VILLAGE OF ANMORE

REPORT TO COUNCIL

Date: January 17, 2020 File Number: 6480-01
Submitted by: Jason Smith, Manager of Development Services
Chris Boit, Engineer, ISL Engineering
Subject: Burrard Commons – Servicing Options

Burrard Commons – Servicing Options

FIGURE 1

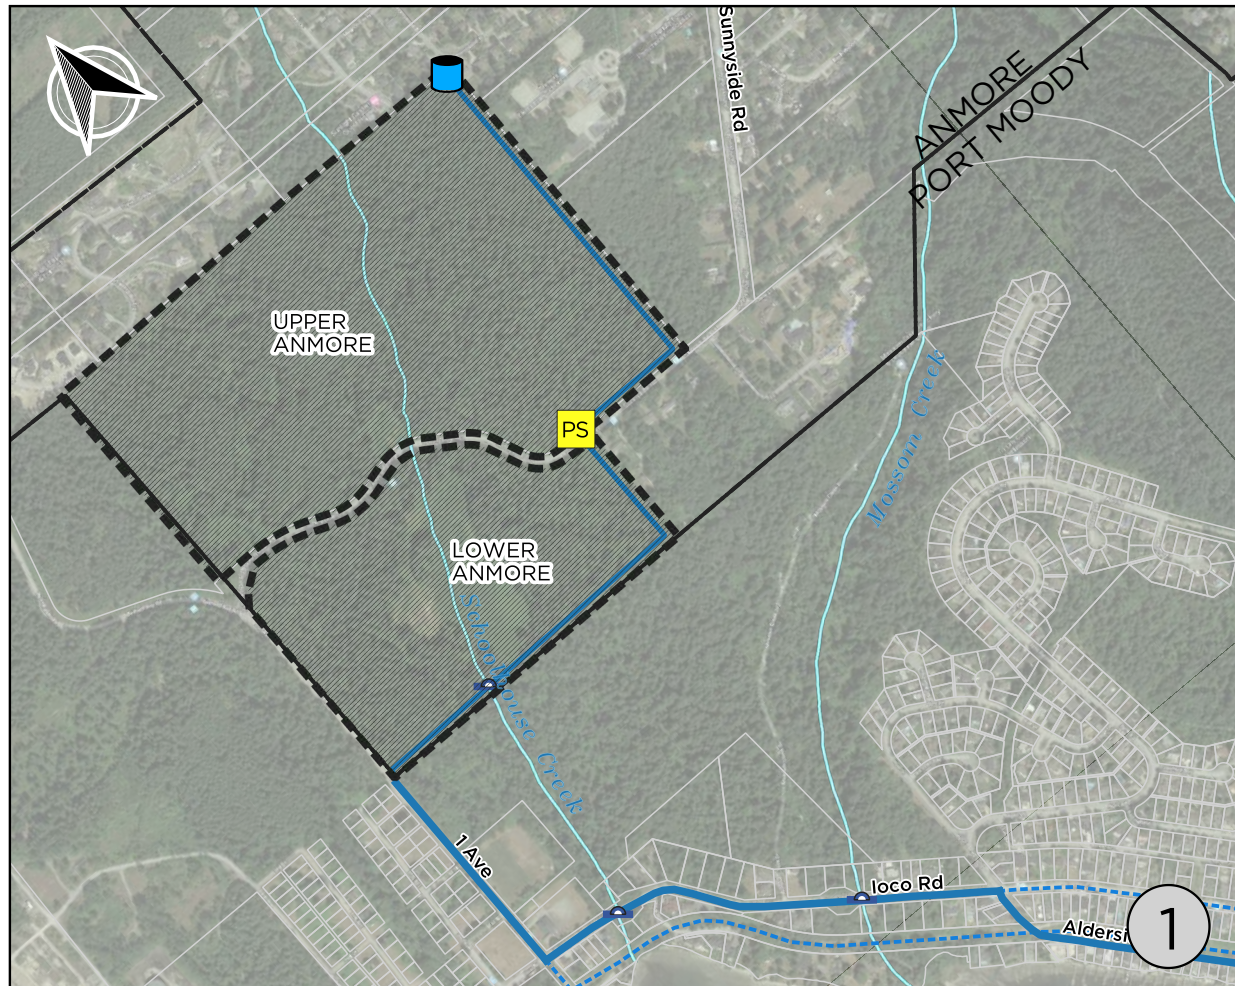
Water Option 1 – Guildford Way to loco Rd (Fig 1 – South Route)

The route proposes to draw Metro Vancouver water from their water main located at Guildford Way. The route would then follow Ungless Way, Alderside Road, loco Road and 1st Avenue where it would then enter the proposed development.

It is staff's opinion that this is the preferred route for the Village. It provides a direct route to the development, minimizes impact to existing residents of Port Moody and Anmore, minimizes the need for booster/pump stations and potentially allows for a second water feed to the Village. The second feed would require the Village to maintain the Port Moody connection.

There is also an added benefit that this route could provide water to any future development on the Port Moody lands. This would add to the business case for Metro Vancouver when considering the extension of the line.
